Department of Energy
Washington, D.C. 20545

Docket No. 50-537
HQ:S:82:065

RESPONSES TO REQUEST FOR ADDITIONAL INFORMATION

Reference: Letter, P. S. Check to J. R. Longenecker, "CRBRP Request for Additional Information," dated April 30, 1982

Figure 5.7-6a Average Channel Sodium Exit Temperature Top of Active Core vs. Time for Loss of Steam Generator Load (Dumping of Water/Steam Sides of Both Evaporators and the Superheater)

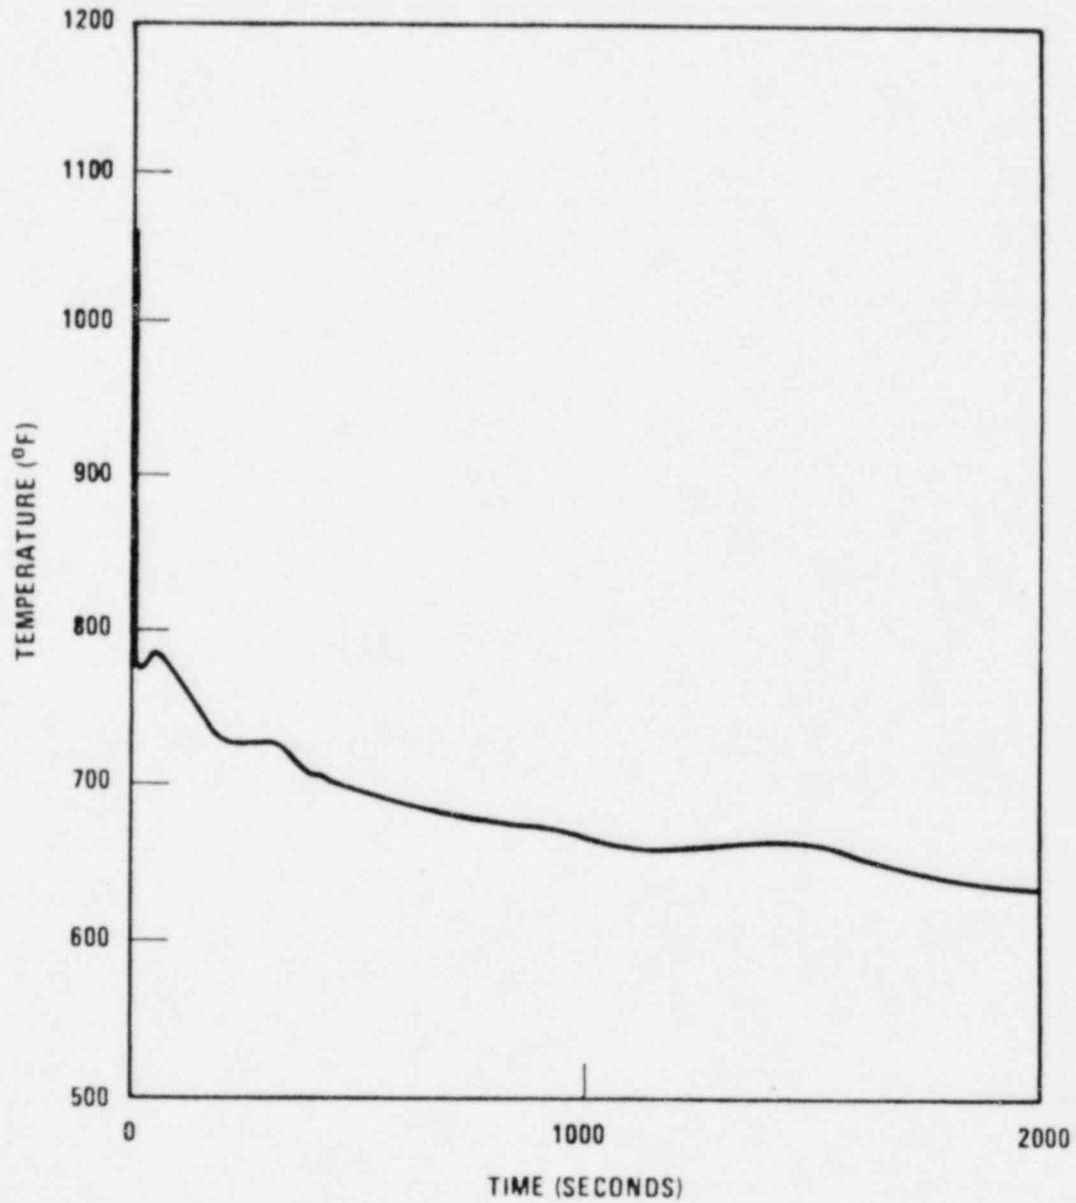
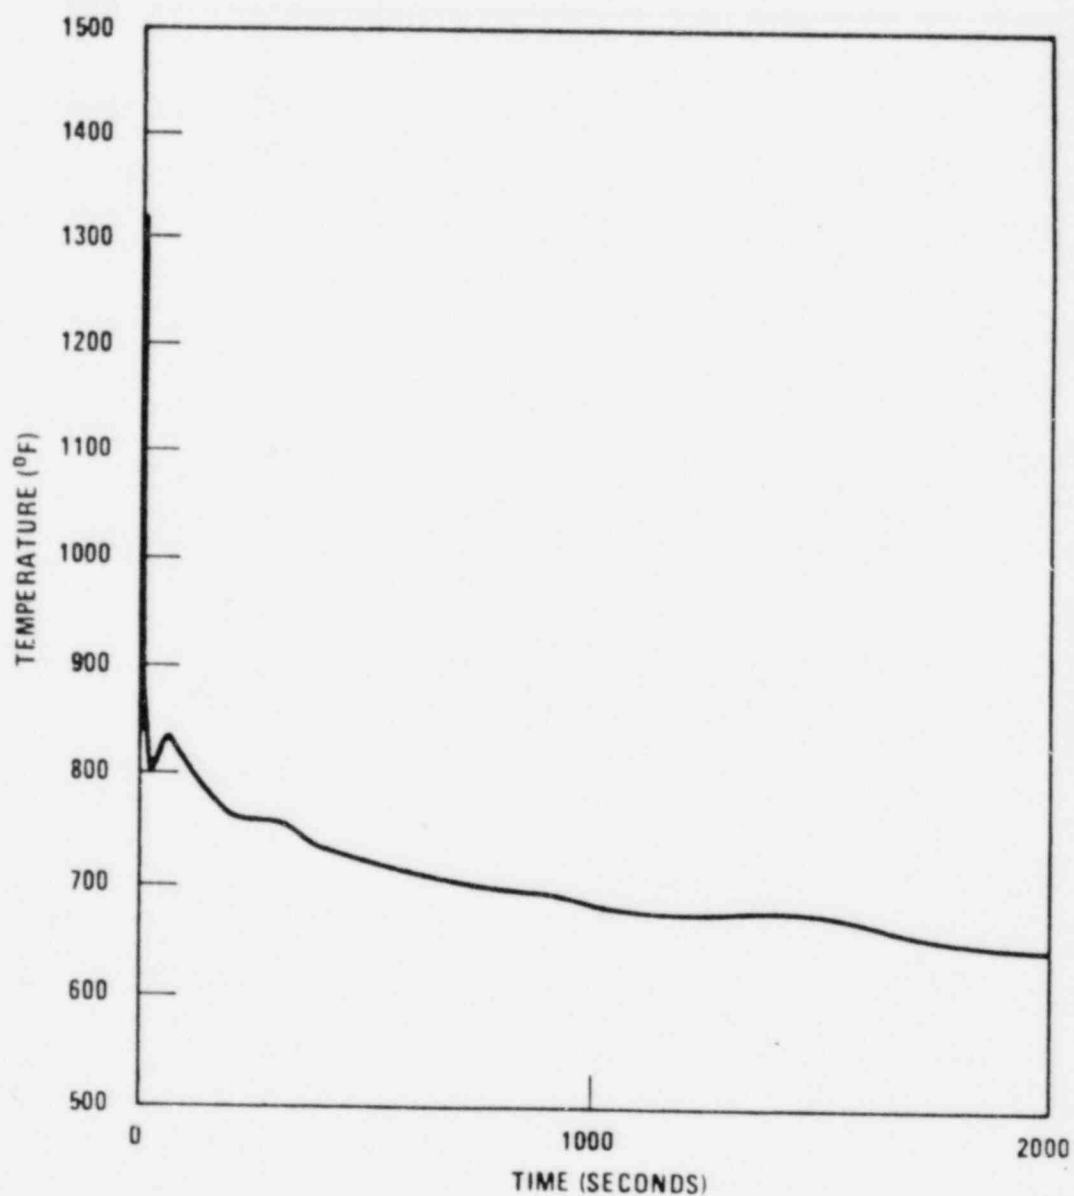
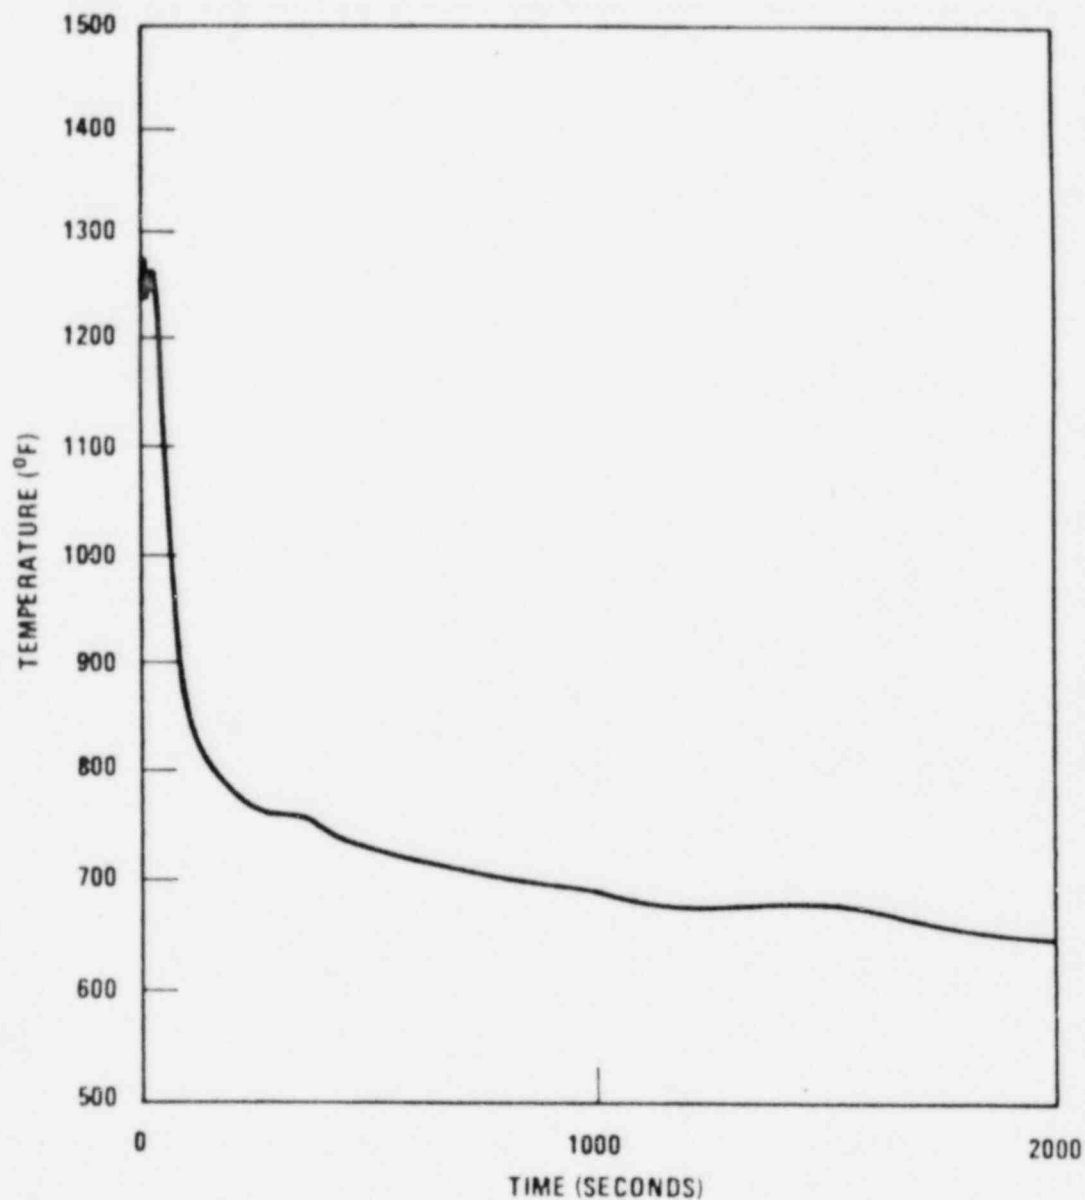
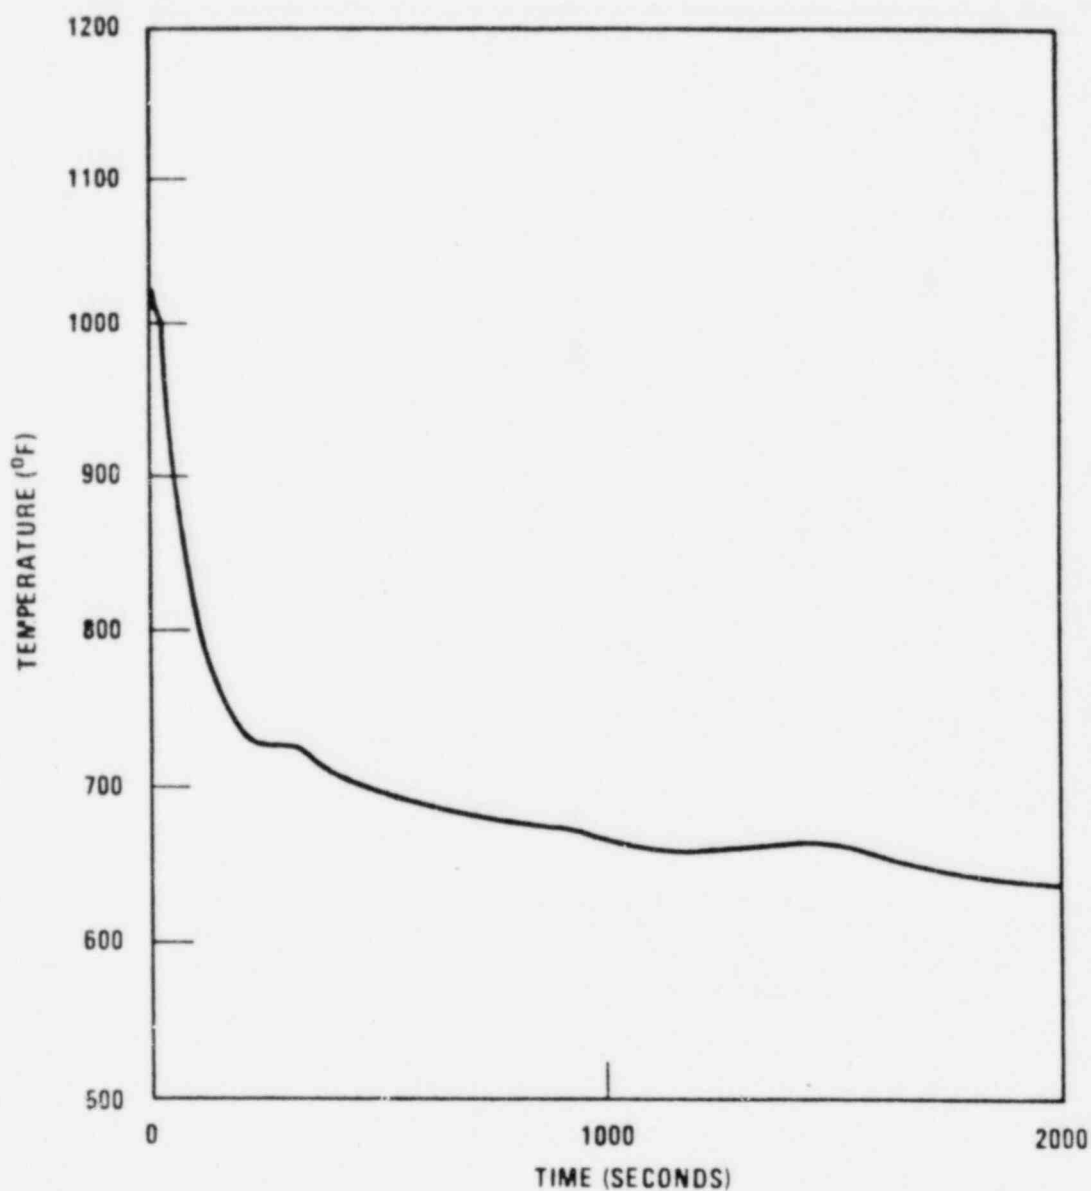
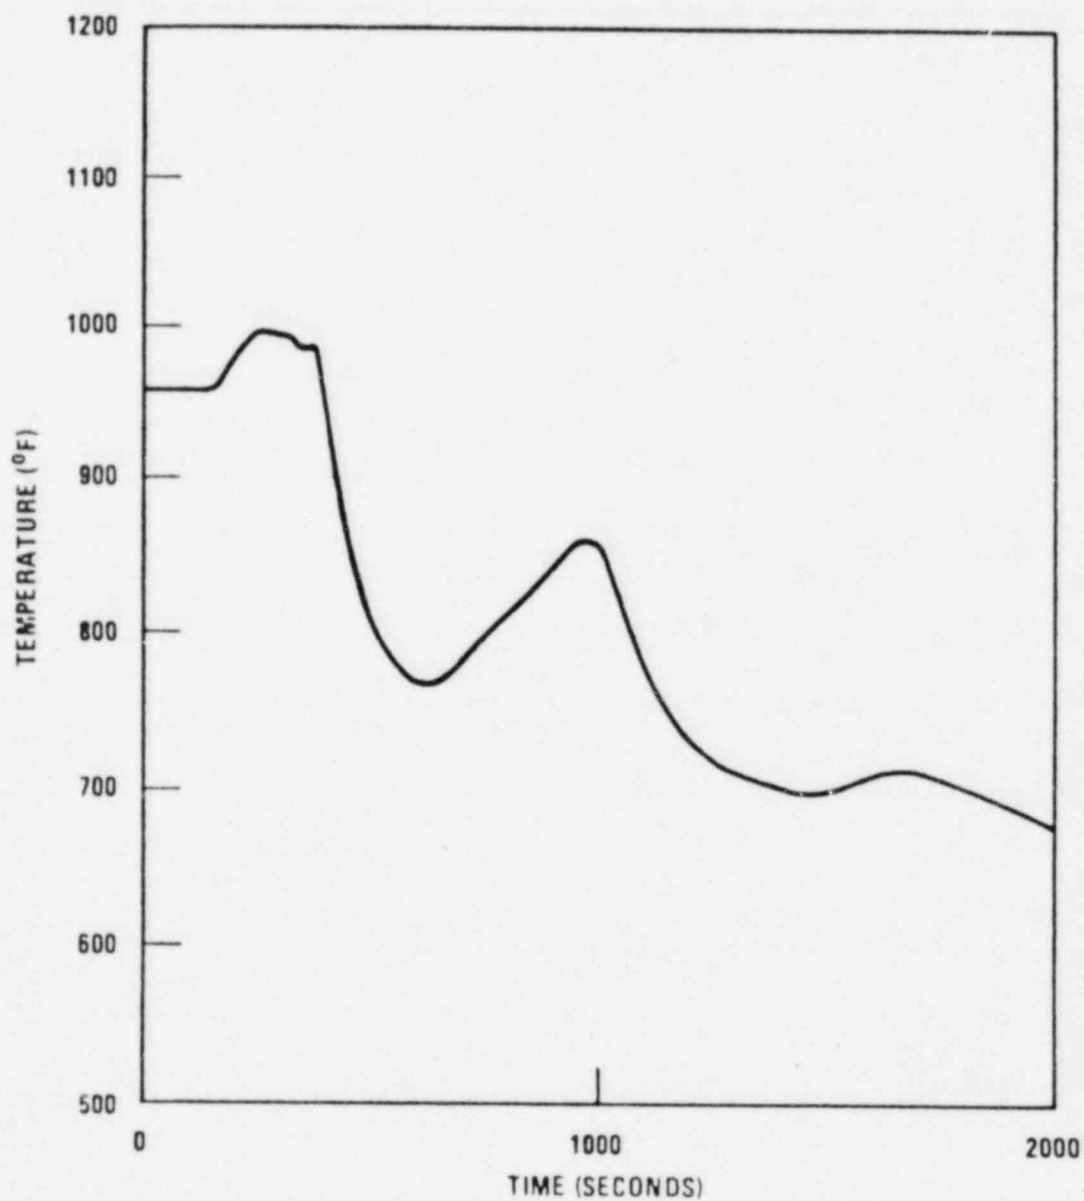
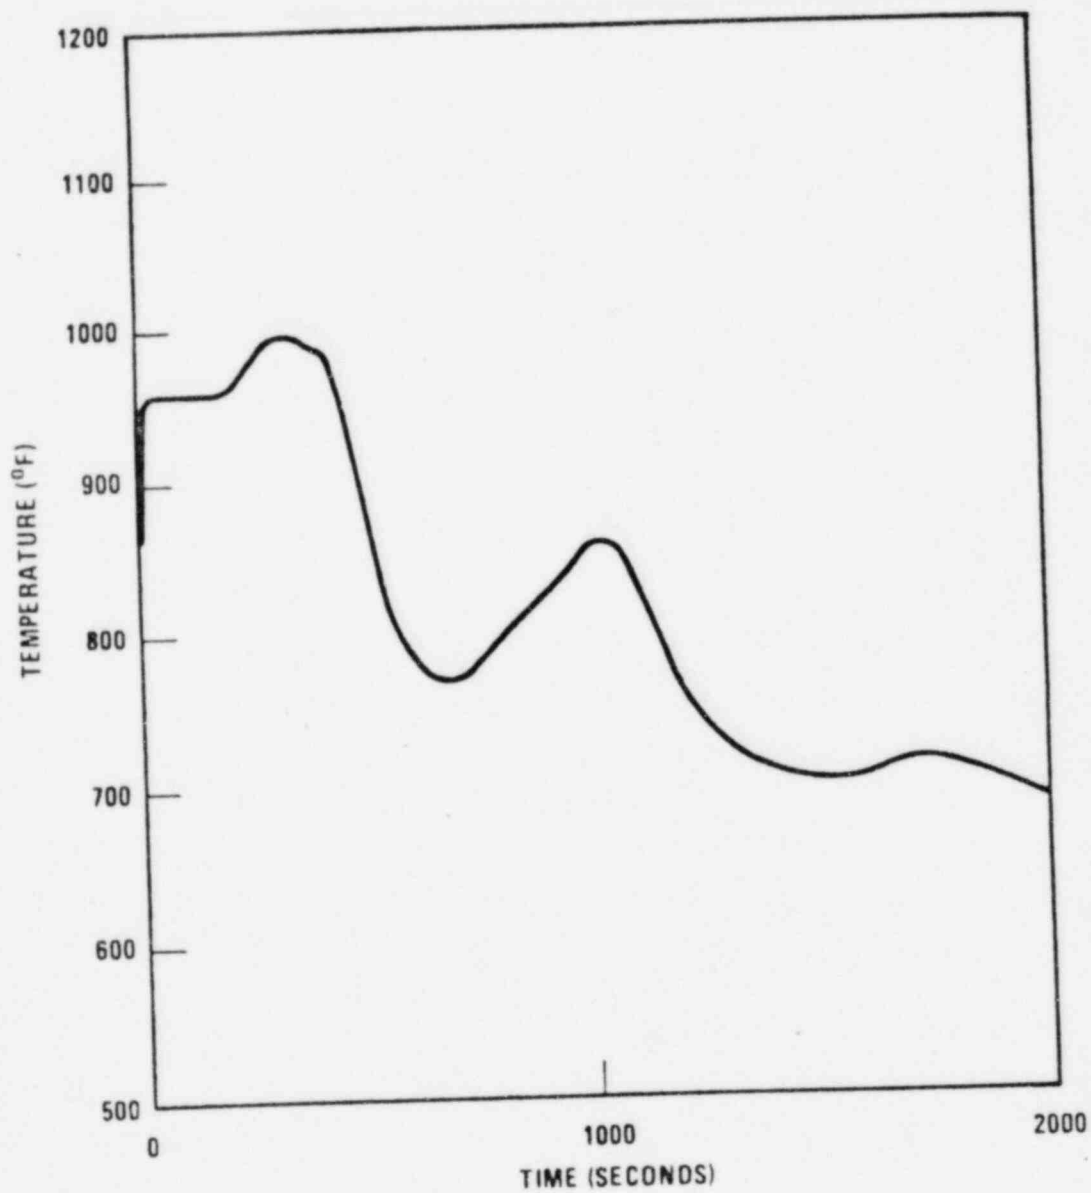
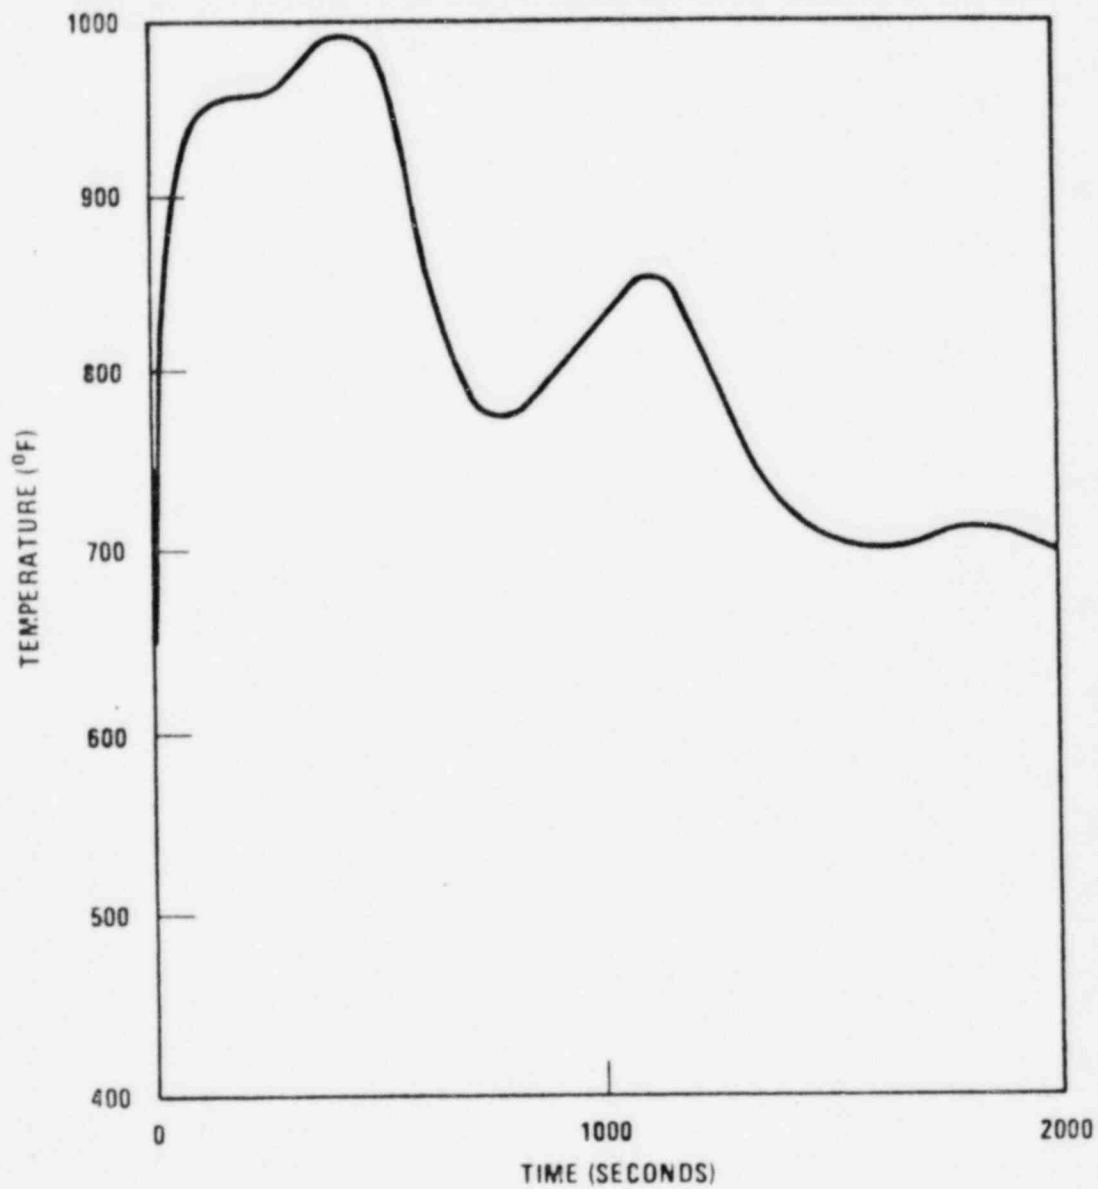
Question CS760.131 Transient Effects (5.7.5)

The steam generator temperature and pressure response and core temperature response is provided in Figures 5.7-6a-k. These data are based on the plant thermal hydraulic design conditions with the hot and cold leg sodium arbitrarily increased 20°F.
